**SERVICE BULLETIN**

**N° 139-463**

**ATA 46 – INSTALLATION OF KIT CENTRAL DISPLAY**

This Service Bulletin is issued in order to provide the necessary instruction on how to perform the installation of the installation of the kit central display Sirio Panel P/N 4G4630F00312.

**Figure 6**

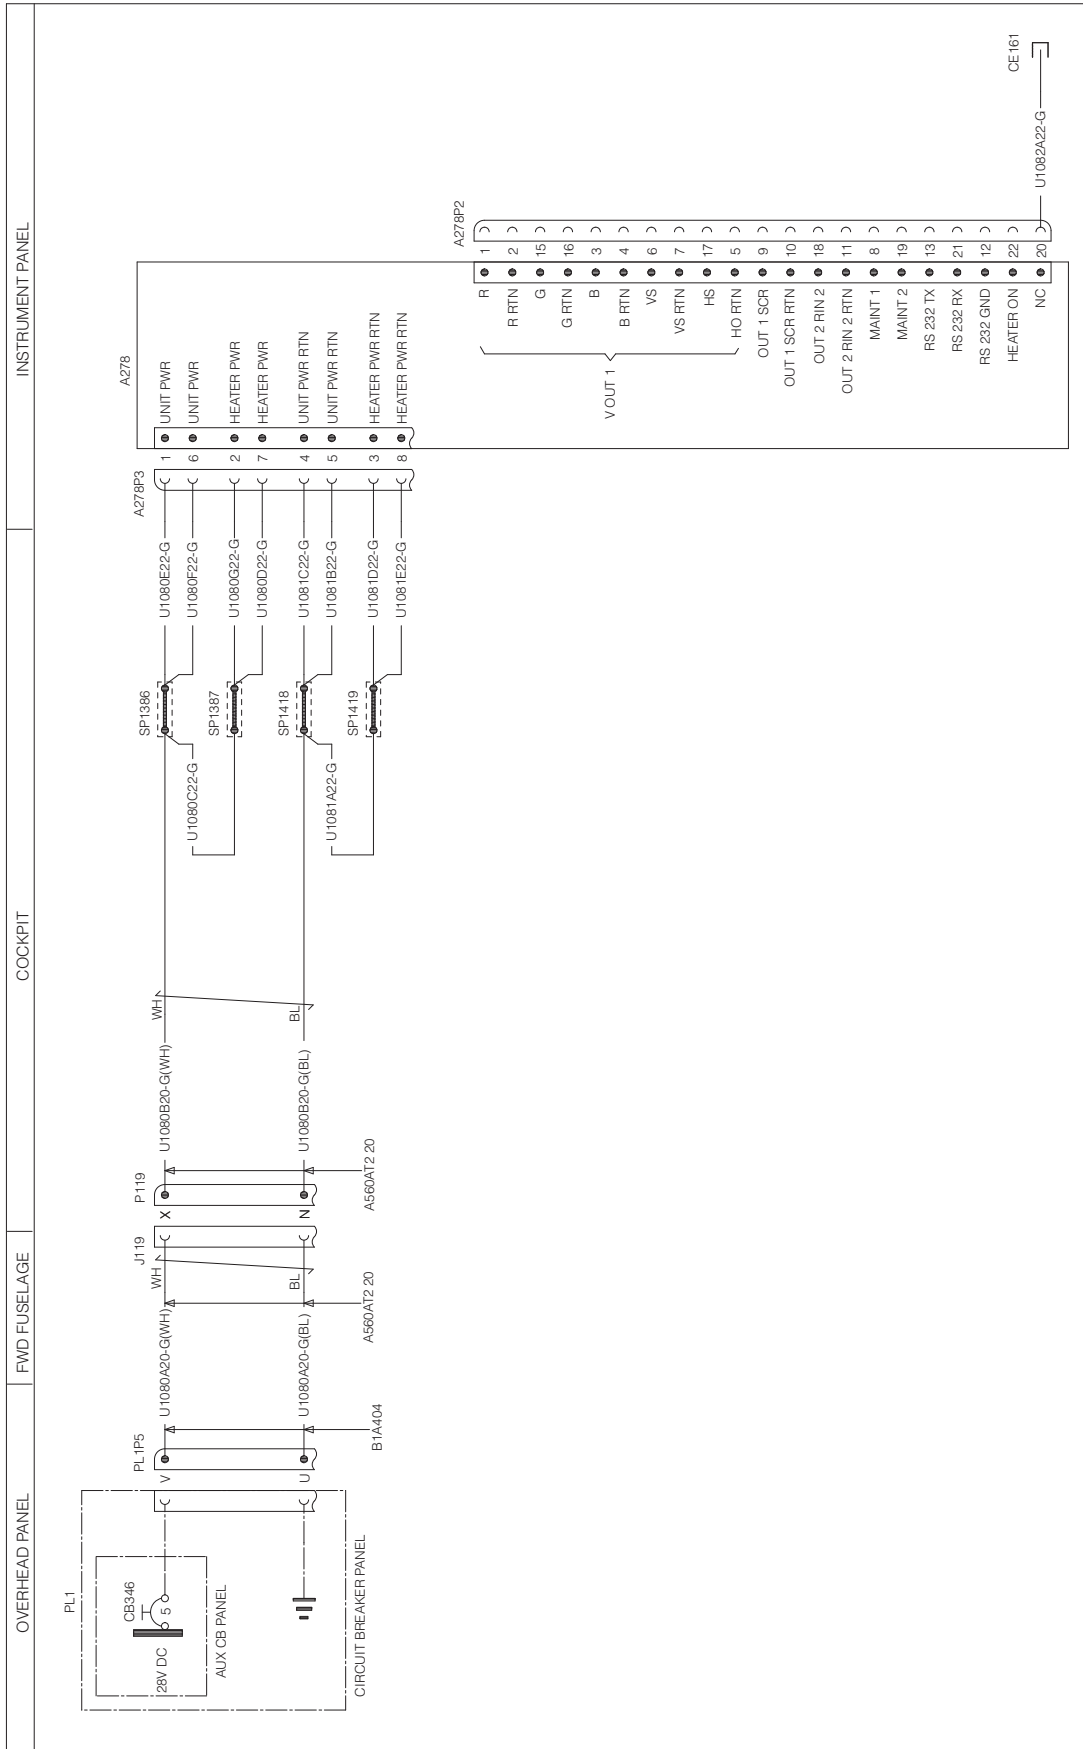
- 9.3 With reference to Figure 6, perform electrical connections between circuit breaker CB346 pin 2 and connector of overhead circuit breaker panel PL1J5 pin V by means of A556AT16 wire. Use terminal lug P/N MS25036-153 for pin 2 of CB346 and electrical contact P/N M39029/56-352 for pin V of PL1J5. Connect CB346 to 28V DC MAIN BUS 2.

- 9.4 With reference to Figure 6, perform electrical connection between the TB504 pin J and the panel PL1J5 pin U by means of A556AT16 wire. Use electrical contact P/N M39029/56-352 for pin U of PL1J5 and 001104-203-02 for terminal board TB504 pin J.
